Pre-Application Meeting (PRE21-052)

Site Location:	7204 78 th Ave SE		
Lot Size:	21,916 sq ft	Zoning:	R-9.6 (Single Family)
Brief Project Description:	Proposal to subdivide existing lot into two lots.	Documents Provided:	<ul style="list-style-type: none">• Project narrative and list of questions• Site plan with tree location information• Topographic survey• Arborist Report
Applicant Information:			
<small>Name:</small>	Peikli Pang	<small>Email:</small>	peikli.pang@5ft2studio.com
		<small>Phone:</small>	425-287-1567
Second Pre-application Meeting Required:	Not Applicable	Click for explanation if necessary

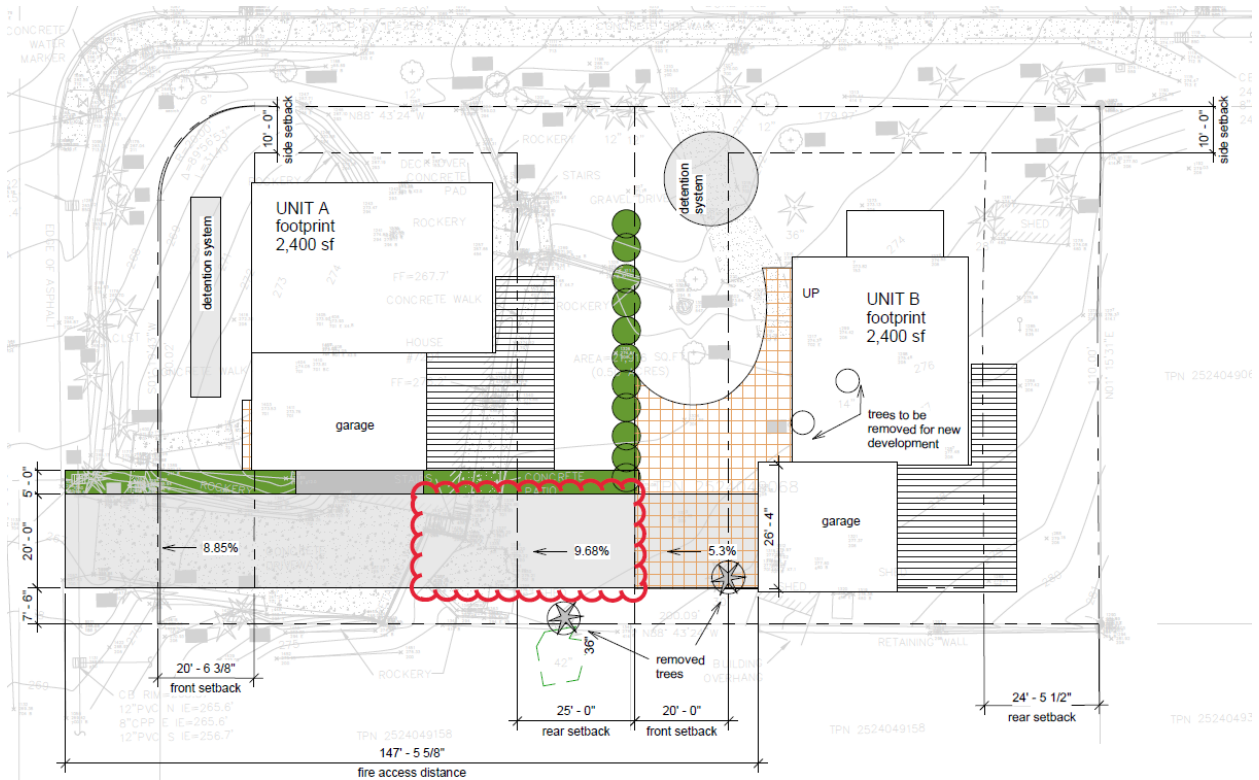
2. Lot coverage: Lot coverage is based on net lot area, does this mean the lot size after deducting easement's area? Please clarify what is net lot area.

The area of the shared access easement on Lot A bubbled in red below would be subtracted from the gross lot area to calculate the net lot area.

Staff Response: Please refer to the definition of "lot area, net" in MICC 19.16.010:

"The area contained within the established boundaries of a lot, less any area used for public or private vehicular access easements, excluding that portion of the easement used for a driveway access to the encumbered lot.

For example, the net lot area of a lot encumbered by a private vehicle access easement with an area of 1,000 square feet and of which 400 square feet of the vehicle access easement is used for a driveway to a home on the encumbered lot is the area within the established boundaries of the lot less 600 square feet."
